- Subject** ▶ Change on motor housing and armature
- For Models** ▶ 9029, 9029S, 9039, 9039S, 9027, 9027S, 9037 and 9037S (Disc Grinder)
- Note** ▶ Ground-down armature will be supplied as replacement parts till July, 1995.
- Description** ▶

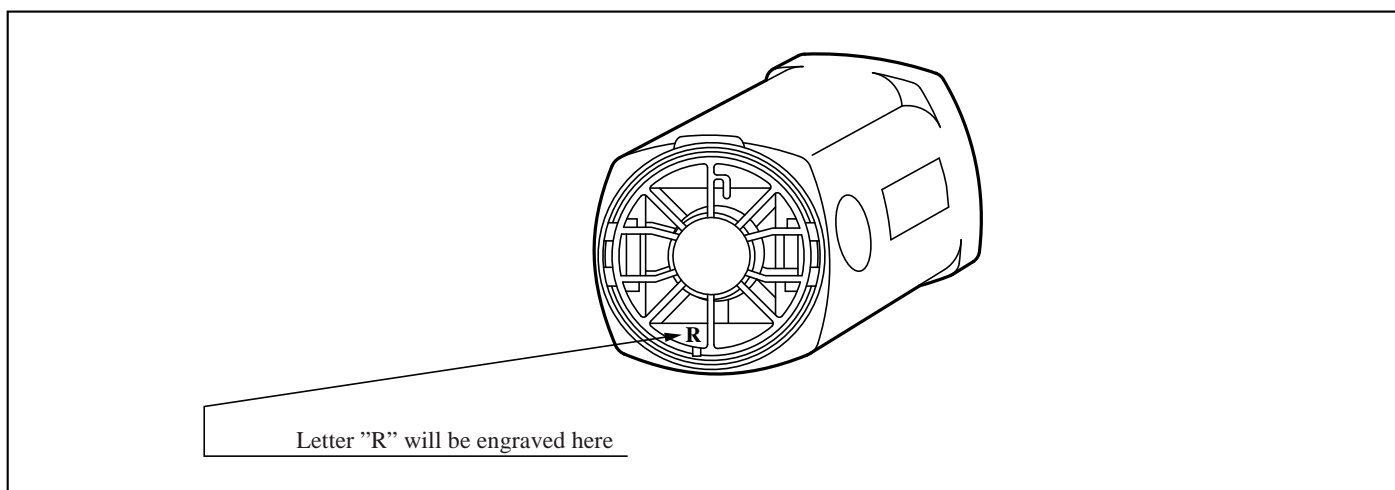
1. The motor housing will be changed in material. To differentiate the new type motor housing from the current type on, letter "R" will be engraved on the new type one as shown in the figure below.
